**Planning Division Staff Response and Recommendation
to Comments Received on the
Draft Pumpkin Hollow Neighborhood Development Plan**

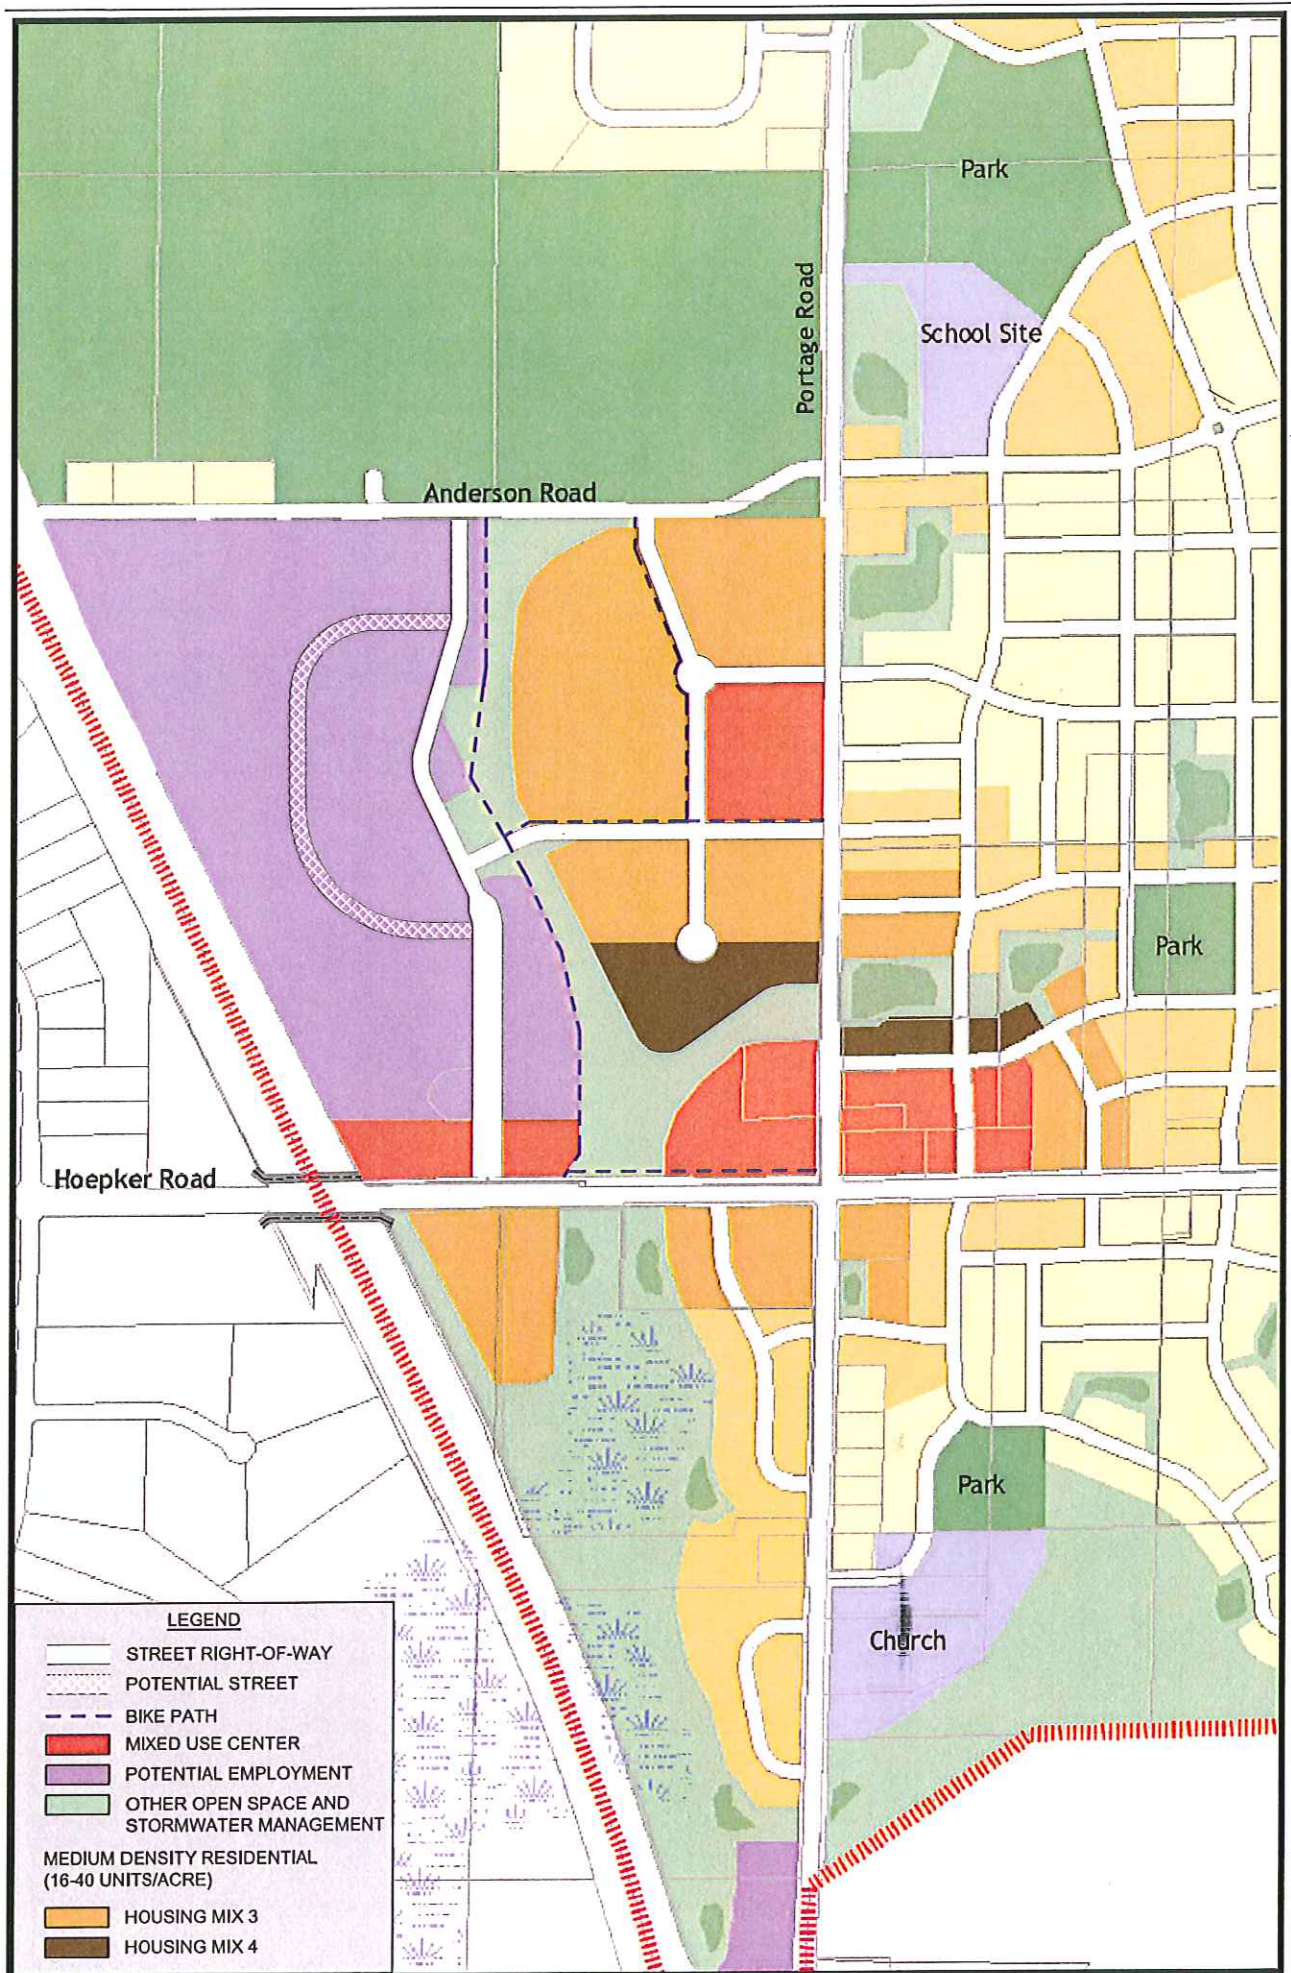
At the December 20, 2007 LRTPC meeting, several additional suggestions were offered during the discussion following a staff presentation on the draft Pumpkin Hollow Neighborhood Development Plan.

17. It was suggested that an additional local street running north-south through the neighborhood be identified as a bicycle connection that should be maintained even if the specific street pattern illustrated in the plan is modified as successive individual developments are approved.

Planning Division staff recommend that the easternmost north-south through street in the portion of the neighborhood that will eventually become part of the City of Madison be identified on the Pedestrian/Bicycle Facilities map (Map 9) as a "Local Through Street for Bicyclists."

Planning Division staff recommend that additional off-street paths be illustrated on Map 9 connecting The American Center with the proposed realigned east-west bicycle path south of Hoepker Road, and with the north-south street recommended to be designated as an additional Local Through Street for Bicyclists.
